TITLE: ${PROJECTNAME}	SFE	SFE
Document Number:		REV: v13
Date: ${CURRENT_DATE}	Sheet: / File: working.kicad_sch	Sheet: ${#}/${##}
	Title:	
	Size: User Date: KiCad E.D.A. eeschema 7.0.6	Rev: Id: 1/1

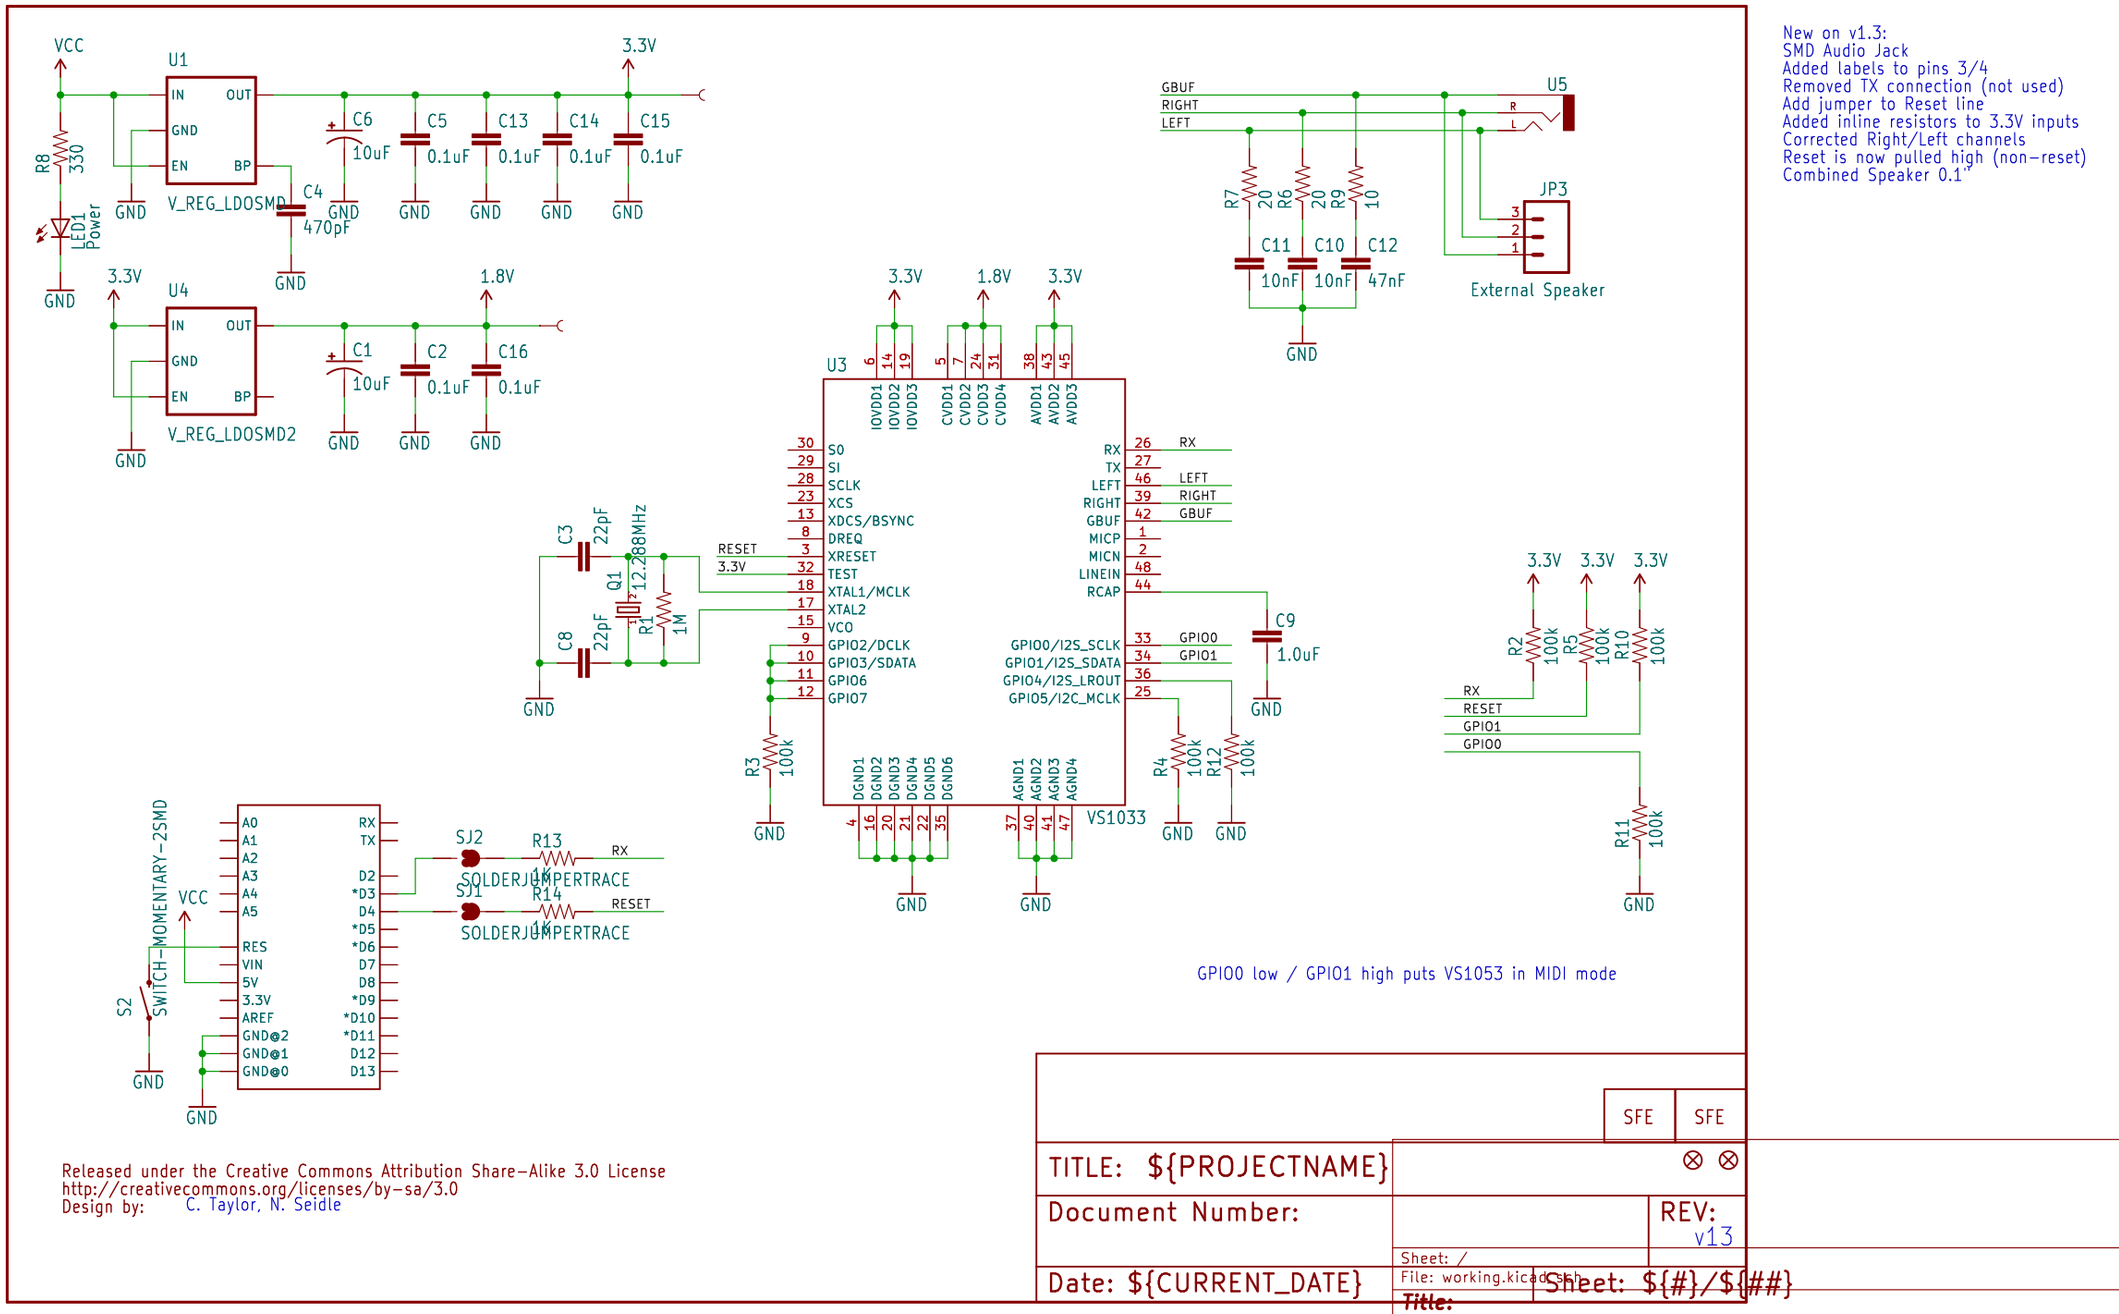
New on v1.3:
SMD Audio Jack
Added labels to pins 3/4
Removed TX connection (not used)
Add jumper to Reset line
Added inline resistors to 3.3V inputs
Corrected Right/Left channels
Reset is now pulled high (non-reset)
Combined Speaker 0.1"
